**IMSA GT3 Cup Challenge Presented by Michelin  
Bulletin GT3 06-03**

Re: Timing transponders and 997 suspension Information.

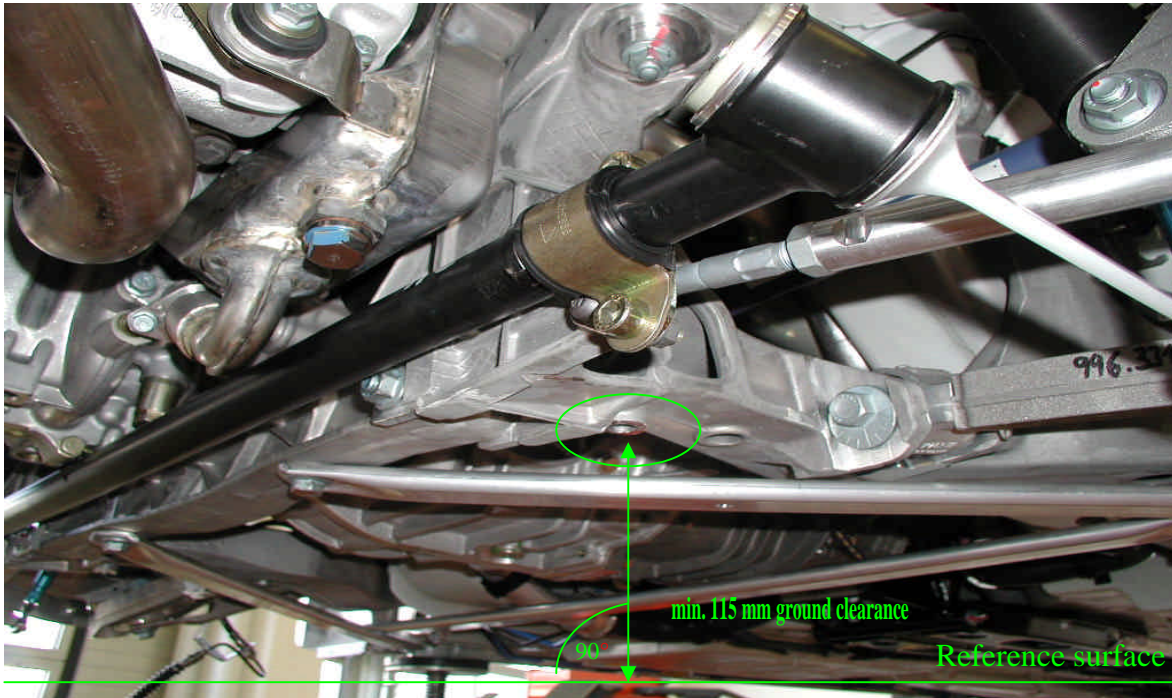
- 
- All GT3 Cup cars are required to use hard-wired AMB transponders for the 2006 season. A limited number of these will be available for purchase at the IMSA tech truck during each event. Please contact Pam Gratiot (IMSA office) in advance to reserve.
  - 997 Cup cars may use a camber shim maximum of 13mm for the front axle and 10mm for the rear
  - 997 minimum ride heights are 77mm front and 115mm rear, measured as referenced in the attached photo
